SUBJECT: Removal Site Evaluation Report/Engineering Evaluation/Cost Analysis (RSER/EE/CA) for C-Area Groundwater Operable Unit (U) (SRNS-RP-2017-00365, Revision 1, February 2018), Savannah River Site Responses to Regulatory Comments on the Revision 0 Document, and Draft Action Memorandum, CERCLIS Number: 82

SRS Responses to U.S. Environmental Protection Agency Comments on Removal Site Evaluation Report/Engineering Evaluation/Cost Analysis (RSER/EE/CA) for C-Area Groundwater Operable Unit (U), CERCLIS Number: 82, SRNS-RP-2017-00365, Revision 0, September 2017, Savannah River Site, South Carolina

**SRS Responses to South Carolina Department of Health and Environmental Control
Comments on: Removal Site Evaluation Report/Engineering Evaluation/Cost Analysis
(RSER/EE/CA) for C-Area Groundwater Operable Unit (U), CERCLIS Number: 82
(SRNS-RP-2017-00365, Revision 0, September 2017) received September 29, 2017.
Page 1 of 6**

Figure 6. CAGW OU TCE Plume, 2016

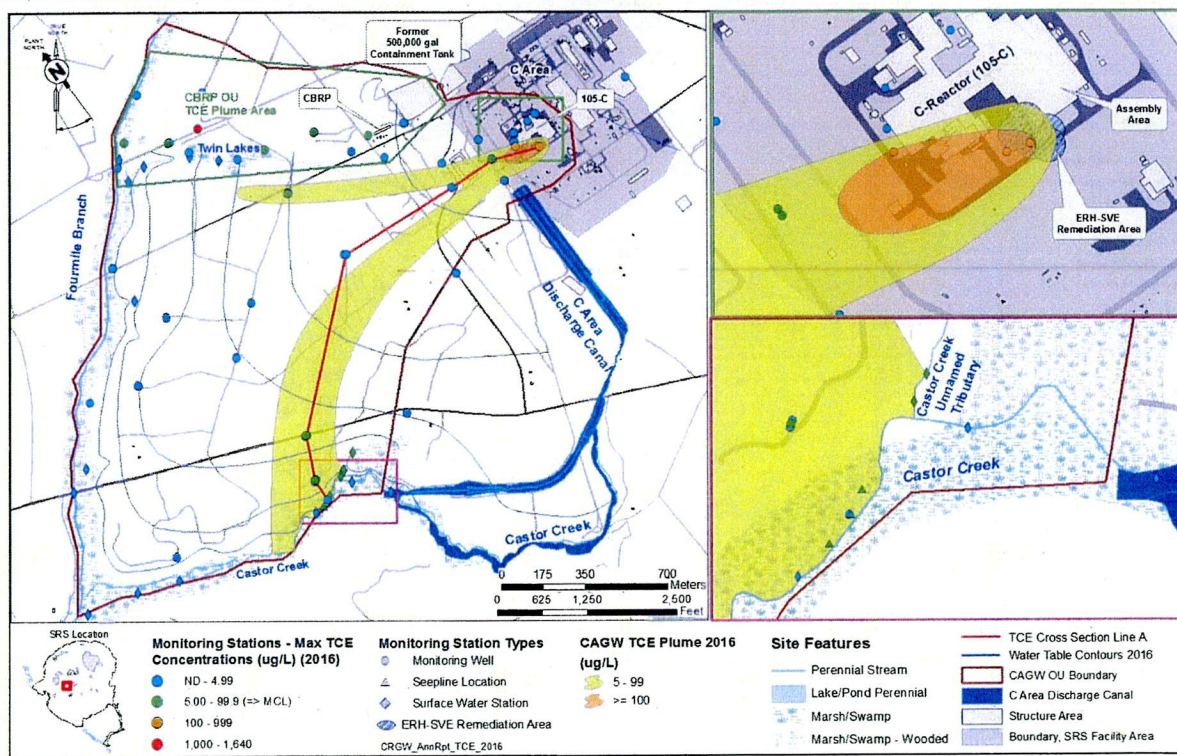
2. In Figure 6, CAGW OU TCE Plume, 2016, Page 31 of 34 of the hard copy of the EE/CA, the enlarged view of the C-Reactor (105-C) located in the upper right corner of the figure depicts several red circles drawn in the electrical resistivity heating-soil vapor extraction (ERH-SVE) remediation area. However, the meaning or purpose of the red circles is unclear as they were not defined in the figure legend. For clarity and completeness, revise the figure to address this issue.

The red circles in Figure 6 indicate the zones of influence of the SVE wells used during and after the electrical resistance heating (ERH) for remediation of TCE in the vadose zone. Figure 6 (see attached) will be revised to identify the ERH-SVE zone of influence on the map and in the legend with a blue cross-hatched pattern as requested in other reports.

Figure 8. CAGW OU Distal TCE Groundwater Plume ISCO Treatment Area

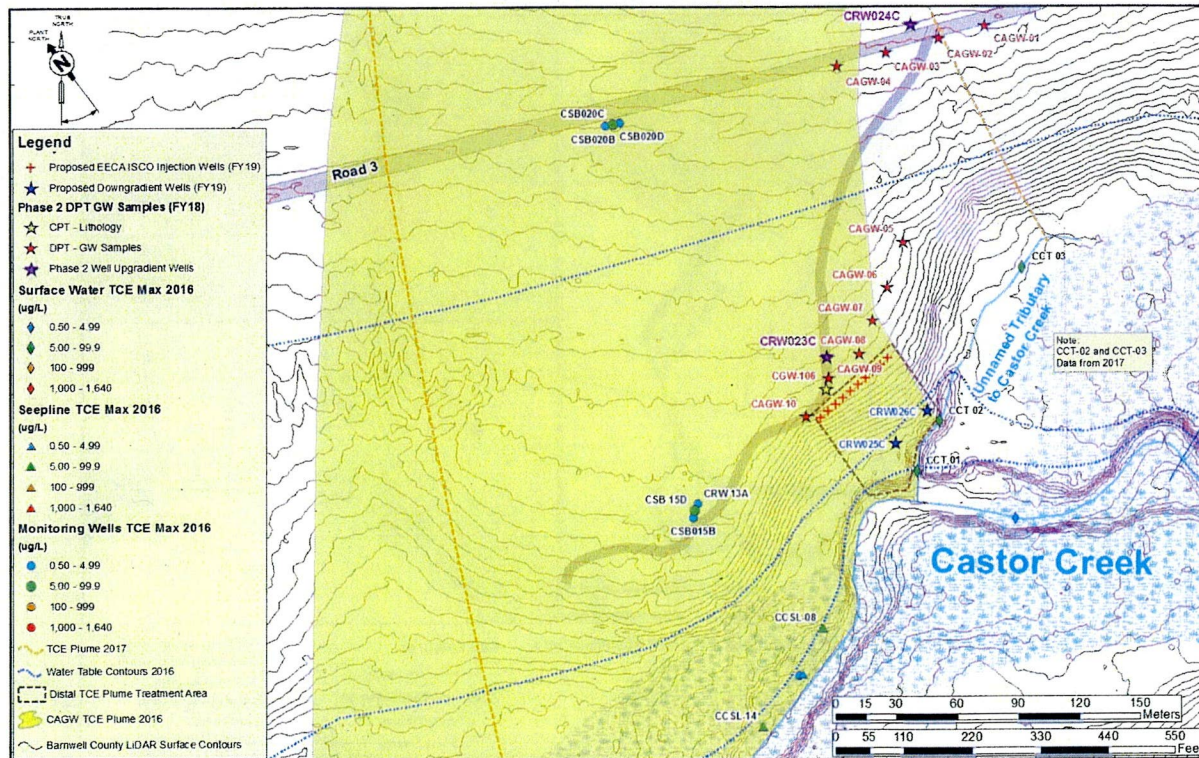
3. In Figure 8, CAGW OU Distal TCE Groundwater Plume ISCO Treatment Area, Page 33 of 34 of the hard copy of the EE/CA the well location symbol (e.g., purple star) for upgradient Phase 2 well "CRW024C" is not visible in the figure. It appears the upgradient well label CAGW 02 for proposed "Phase 2 DPT" groundwater sample is covering well location CRW024C. For clarity and completeness, revise the figure to address this issue.

Figure 8 (see attached) will be revised to show the symbol for well CRW024C.

Figure 4. CAGW OU TCE Plume, 1998 to 2002

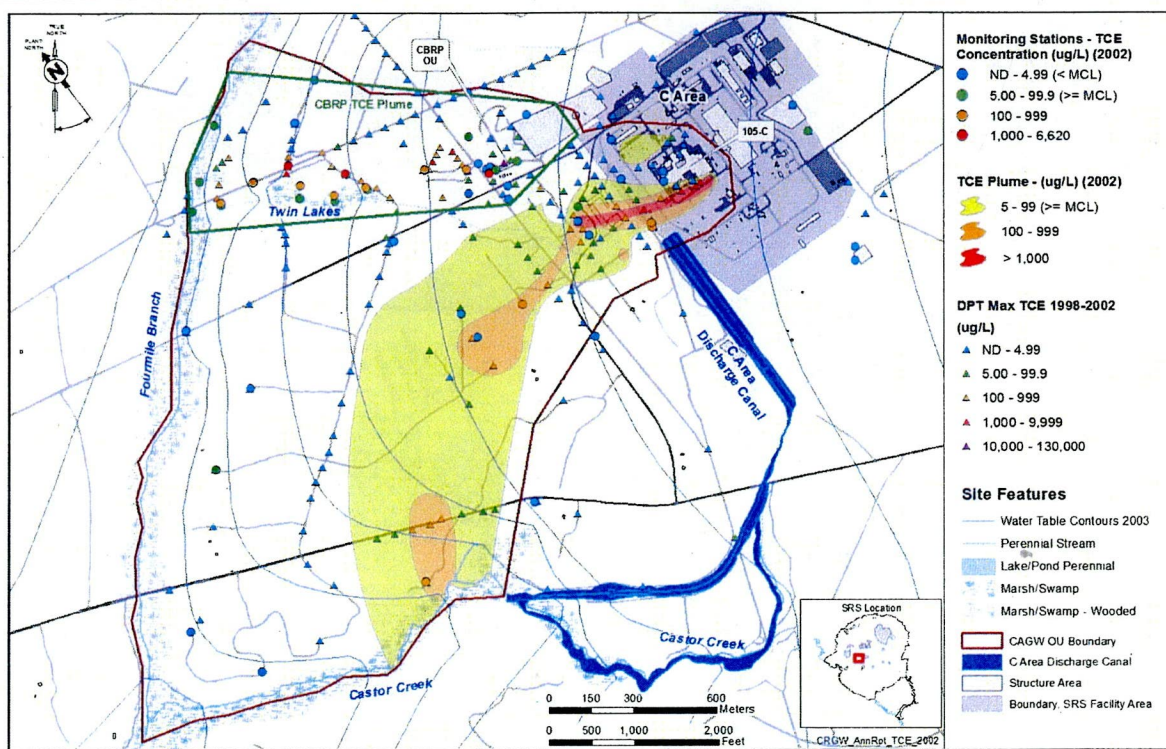
3. Figures 4, 6-8, pages 29, 31-33. The TCE concentration data points (5 ug/L-99 ug/L) are the same color of the TCE plume and are difficult to see. Please consider choosing a different color for the data points.

Figures 4, 6, 7 and 8 (see attached) will be revised to use a bright green color for TCE concentration data points between 5 µg/L and 99 µg/L.
